**Economic and Social Council**Distr.: General
7 August 2017

Economic Commission for Europe**Inland Transport Committee****World Forum for Harmonization of Vehicle Regulations****Working Party on Lighting and Light-Signalling****Seventy-eighth session**

Regulations Nos. 37 (Filament lamps), 99 (Gas discharge light sources), 128 (Light emitting diodes light sources) and the Consolidated Resolution on the common specification of light source categories**Proposal for amendments to the original version of the Consolidated Resolution on the common specification of light source categories****Submitted by the expert from the International Automotive Lighting and Light Signalling Expert Group (GTB)***

Figure 1
Main drawing

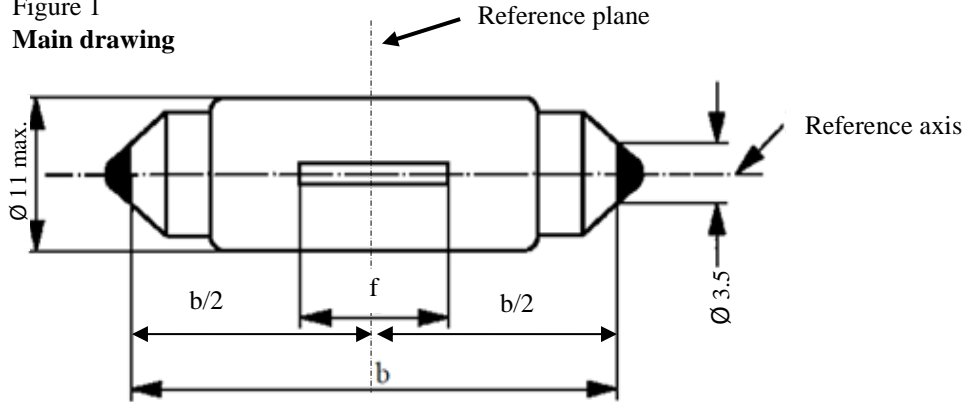
Before sheet LR1/1, insert new sheets C5W/LED/1 to 4, to read (see following pages; one page per sheet):

The drawings are intended only to illustrate the essential dimensions (in mm) of the LED light source.

Dimensions in mm		LED light sources of normal production			Standard LED light source
		min.	nom.	max.	
b ^{1/}		34.0	35.0	36.0	35±0.5
e ^{2/}			0.0		0.0
f ^{2/}			9.0		9.0
Cap SV8.5 in accordance with IEC Publication 60061 (sheet 7004-81-4)					
Electrical ^{5/} and photometric characteristics					
Rated values	Volts	12			12
	Watts	2			2
Test voltage	Volts	13.5			13.5
Objective values	Watts	2 max.			2 max.
	Electrical current (in mA at 9-16V DC)	75 min. 170 max.			
	Luminous flux ^{3/} (in lm at 13.5 V DC)	45 ± 20 % ^{4/}			45 ± 10 % ^{4/}
	Luminous flux ^{3/} (in lm at 9 V DC)	9 min.			9 min.

¹ This dimension corresponds to a distance between two apertures of 3.5 mm diameter each bearing against one of the caps.
² To be checked by a “box system”, see Figure 2.
³ The light emitted from LED light source shall be white.
⁴ The value measured at elevated ambient air temperature of 80°C shall be at least 70% of this value.
⁵ In case of a failure of any of the light emitting elements, the LED light source shall either still comply to the requirements concerning luminous flux and luminous intensity distribution or stop emitting light whereby in the latter case the electrical current draw, when operated between 12 V and 14 V, shall be less than 25 Ma.

Figure 2

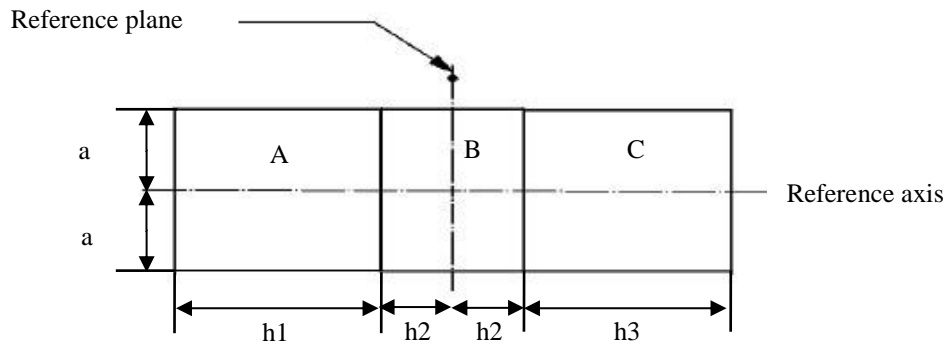
The position of the light emitting area is checked by means of a box system defined by the projections when viewing along the direction $\gamma = 0^\circ$ (top view), $\gamma = 90^\circ$ (front view), $\gamma = 180^\circ$ (bottom view), $\gamma = 270^\circ$ (rear view), inclined views $\gamma = 45^\circ$, $\gamma = 135^\circ$, $\gamma = 225^\circ$ and $\gamma = 315^\circ$, in the plane C_0 (C, γ as defined in Figure 3).

The proportion of the total luminous flux emitted into these viewing directions from the area(s) as defined in figure 2:

- A, B and C together shall be 70 per cent or more;
- B shall be 20 per cent or more;
- A and C shall each be 15 per cent or more.

Dimension (mm)	<i>a</i>	<i>h1, h3</i>	<i>h2</i>
All views (as specified above)	2.5	6	2

Figure 3

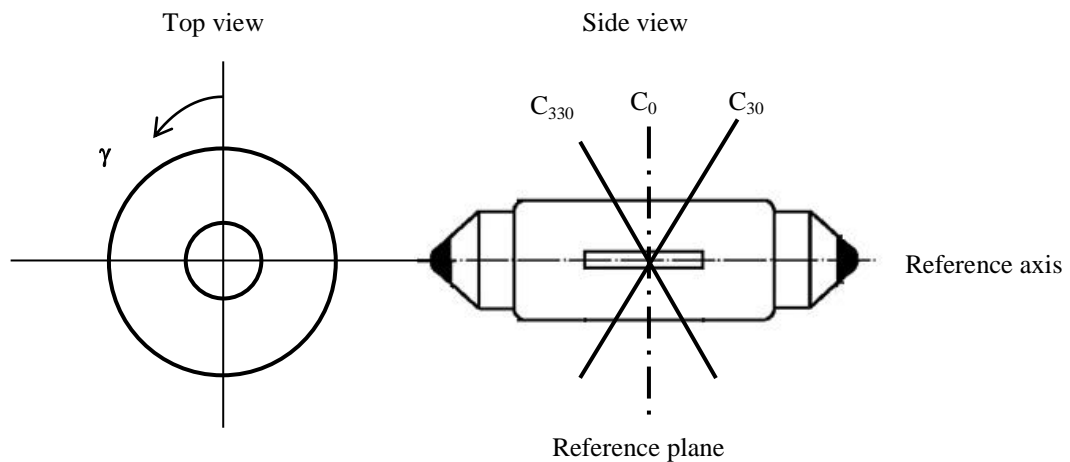
The following test is intended to determine the normalized luminous intensity distribution of the light source in the C-planes as described in figure 3. The intersection of the reference axis and the reference plane is used as the coordinate system origin.

The light source is mounted on a flat plate with the corresponding holder features. The plate is fixed to the goniometer table by a bracket, so that the reference axis of the light source lines up with one of the rotating axis of the goniometer. The corresponding measurement set-up is described in figure 3.

The measurements shall be performed in C-planes, where C_0 shall be the reference plane of the light source. The C-planes to be measured shall be C_0 , C_{30} and C_{330} . The test points for each plane and multiple polar angles γ are specified in Table 3.

Figure 1
Main drawing

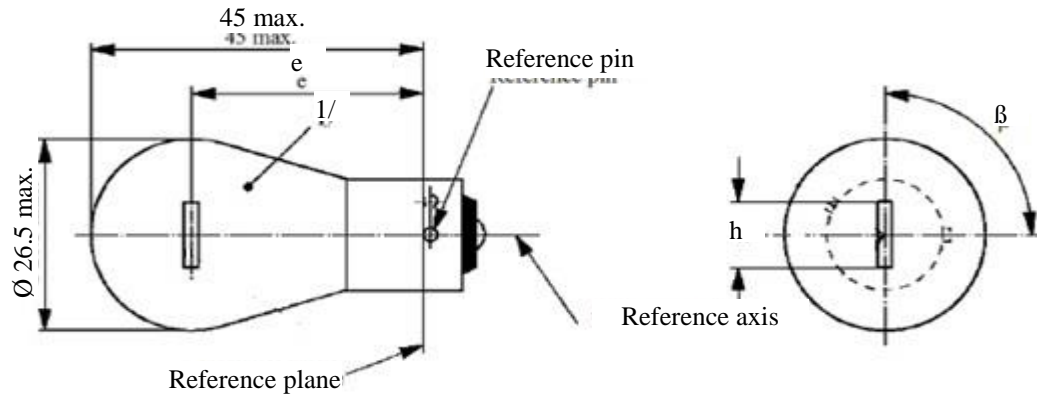
After sheet L5/6, insert new sheets PY21W/LED/1 to 4 and R5W/LED/1 to 4, to read (see following pages; one page per sheet):

The drawings are intended only to illustrate the essential dimensions (in mm) of the LED light source.

Dimensions in mm		LED light sources of normal production			Standard LED light source
		min.	nom.	max.	nom.
e			31.8 ^{2/}		31.8 ^{2/}
h			9.0 ^{2/}		9.0 ^{2/}
β		75°	90°	105°	90°±10°
Cap BAU15s in accordance with IEC Publication 60061 (sheet 7004-19-2)					
Electrical ^{5/} and photometric characteristics					
Rated values	Volts	12	24	12	
	Watts	7 ^{3/}			7 ^{3/}
Test voltage	Volts	13.5	28.0	13.5	
Objective values	Watts	9 max. ^{3/}	10 max. ^{3/}	9 max. ^{3/}	
	Electrical current (in mA at 9-16V DC)	150 min. 750 max.			
	Luminous flux ^{3/, 4/} (in lm at 13.5 V DC)	280 ± 20 %			280 ± 10 %
	Luminous flux ^{3/} (in lm at 9 V DC)	56 min.			56 min.

¹ The light emitted from the LED light source shall be amber.
² To be checked by means of a "Box-System"; sheet PY21W/LED/2.
³ Operated in flashing mode for 30 minutes (frequency = 1.5 Hz, duty cycle 50 per cent ON, 50 per cent OFF) and measured in the ON-state of flashing mode after 30 minutes of operation.
⁴ The value measured at elevated ambient temperature of 80°C shall be at least 65% of this value.
⁵ In case of a failure of any of the light emitting elements, the LED light source shall either still comply to the requirements concerning luminous flux and luminous intensity distribution or stop emitting light whereby/in the latter case the electrical current draw, when operated between 12 V and 14 V, shall be less than 50 mA.

Figure 2

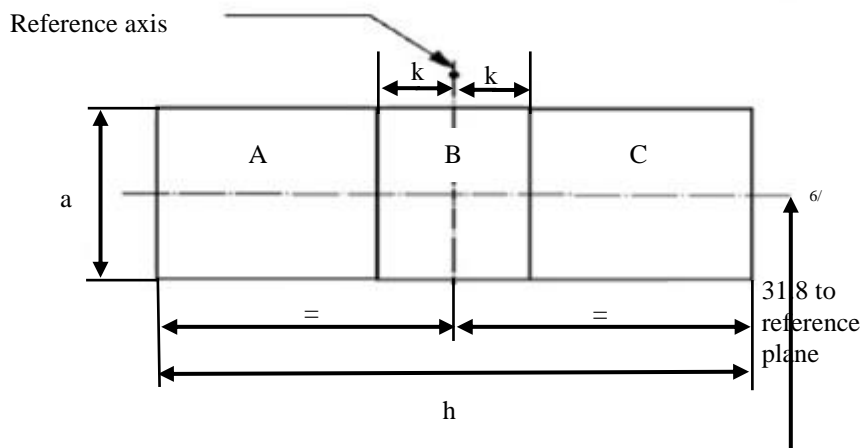
The position of the light emitting area is checked by means of a box system defined by the projections when viewing along direction $\gamma = 0^\circ$ (top view), $\gamma = \pm 45^\circ$ (inclined view) and $\gamma = \pm 90^\circ$ (front and rear view) in the plane C_0 (C, γ as defined in Figure 3).

The proportion of the total luminous flux emitted into these viewing directions from the area(s) as defined in figure 2:

- A, B and C together shall be 80 per cent or more;
- B shall be 25 per cent or more;
- A and C shall each be 15 per cent or more.

The lateral position of the light emitting area needs to be centred in the plane containing the reference axis and being perpendicular to the plane containing the reference axis and the reference pin.

<i>Dimensions in mm</i>	<i>a</i>	<i>h</i>	<i>k</i>
Top view ($\gamma = 0^\circ$)	5.0	9.0	1.0
Inclined view ($\gamma = \pm 45^\circ$)	7.0		
Front / Rear view ($\gamma = \pm 90^\circ$)	5.0

Figure 3

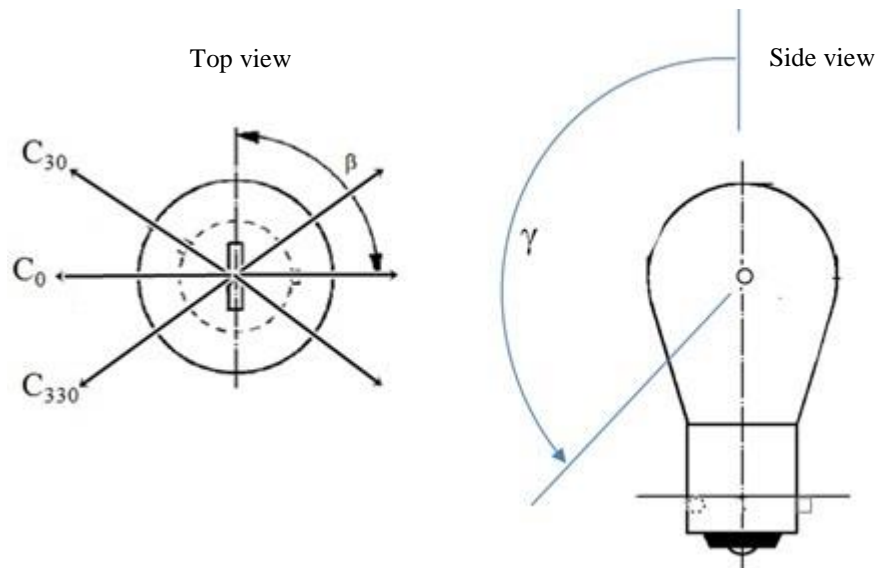
The following test is intended to determine the normalized luminous intensity distribution of the light source in the planes containing the reference axis as described in figure 3. The intersection of the reference axis and the edge of the box is used as the coordinate system origin.

The light source is mounted on a flat plate with the corresponding mounting lug features. The plate is mounted to the goniometer table by a bracket, so that the reference axis of the light source lines up with one of the rotating axis of the goniometer.

The measurements shall be performed in C-planes, which contain the reference axis of the light source. The C-planes shall be C_0 , C_{30} and C_{330} . The test points for each plane and multiple polar angles γ are specified in Table 3.

Figure 1
Main drawing

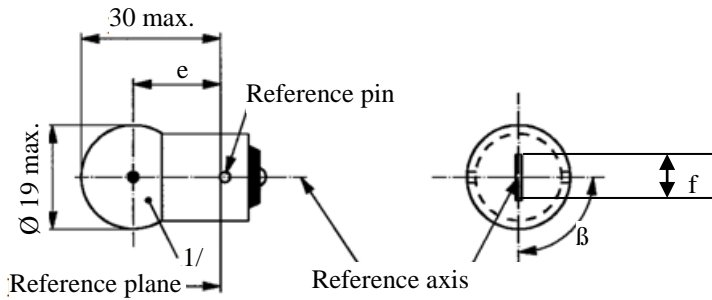
The drawings are intended only to illustrate the essential dimensions (in mm) of the LED light source

Dimensions in mm		LED light sources of normal production			Standard LED light source
		min.	nom.	max.	nom.
e ^{2/}			19.0		19.0
f ^{2/}			4.0		4.0
β ^{2/}			90°		90°
Cap: R5W: BA15s in accordance with IEC Publication 60061 (sheet 7004-11A-9)					
Electrical ^{4/} and photometric characteristics					
Rated values	Volts		12	24	12
	Watts		2		2
Test voltage	Volts		13.5	28.0	13.5
Objective values	Watts		2 max.	2 max.	2 max.
	Electrical current (in mA at 9-16V DC)		75 min. 170 max.		
	Luminous flux ^{1/,3/} (in lm at 13.5 V DC)		50 ± 20 %		50 ± 10 %
	Luminous flux ^{1/} (in lm at 9 V DC)		10 min.		10 min.

¹ The light emitted from LED light source shall be white.

² To be checked by means of a “box system”, sheet R5W/2/LED.

³ The value measured at elevated ambient temperature of 80°C shall be at least 70% of this value.

⁴ In case of a failure of any of the light emitting elements, the LED light source shall either still comply to the requirements concerning luminous flux and luminous intensity distribution or stop emitting light whereby ^{1/}in the latter case the electrical current draw, when operated between 12 V and 14 V, shall be less than 25 Ma.

Figure 2

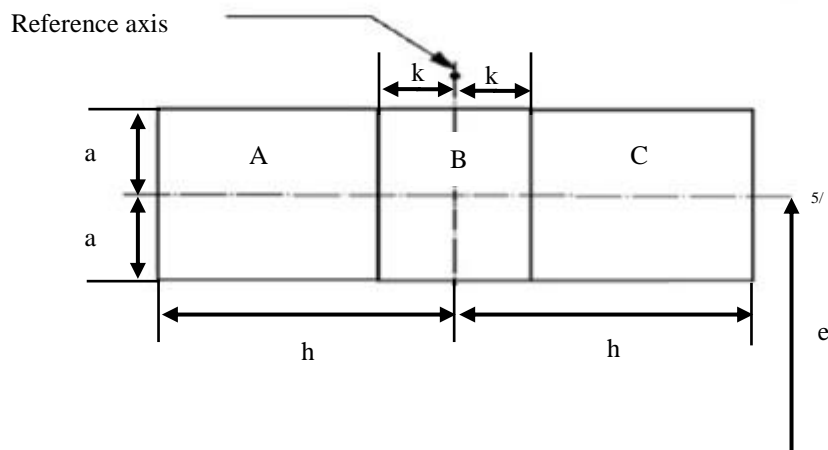
The position of the light emitting area is checked by a box system defined by the projections when viewing along the direction $\gamma = 0^\circ$ (top view), $\gamma = \pm 45^\circ$ (inclined view) and $\gamma = \pm 90^\circ$ (front, rear view) in the plane C_0 (C, γ as defined in Figure 3).

The proportion of the total luminous flux emitted into these viewing directions from the area(s) as defined in figure 2:

- A, B and C together shall be 70 per cent or more;
- B shall be 20 per cent or more;
- A and C shall each be more than 15 per cent.

<i>Dimensions in mm</i>	<i>a</i>	<i>h</i>	<i>k</i>
Top view ($\gamma = 0^\circ$)	3	4	0.5
Inclined views ($\gamma = \pm 45^\circ$)	4.5	4	0.5
Front/ Rear view ($\gamma = \pm 90^\circ$)	3	4	0.5

Figure 3
Illustration of C, γ System

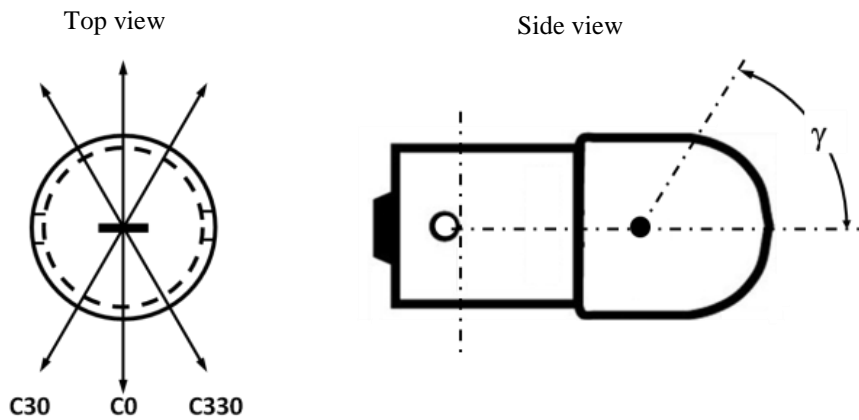
The following test is intended to determine the normalized luminous intensity distribution of the light source in the C-planes as described in figure 3. The intersection of the reference axis and the parallel plane to the reference plane in distance e is used as the coordinate system origin.

The light source is mounted on a flat plate with the corresponding holder features. The plate is fixed to the goniometer table by a bracket, so that the reference axis of the light source lines up with one of the rotating axis of the goniometer. The corresponding measurement set-up is described in figure 3.

The measurements shall be performed in C-planes, which contain the reference axis of the light source. The C-planes to be measured shall be C₀, C₃₀ and C₃₃₀. The test points for each plane and multiple polar angles γ are specified in Table 3.
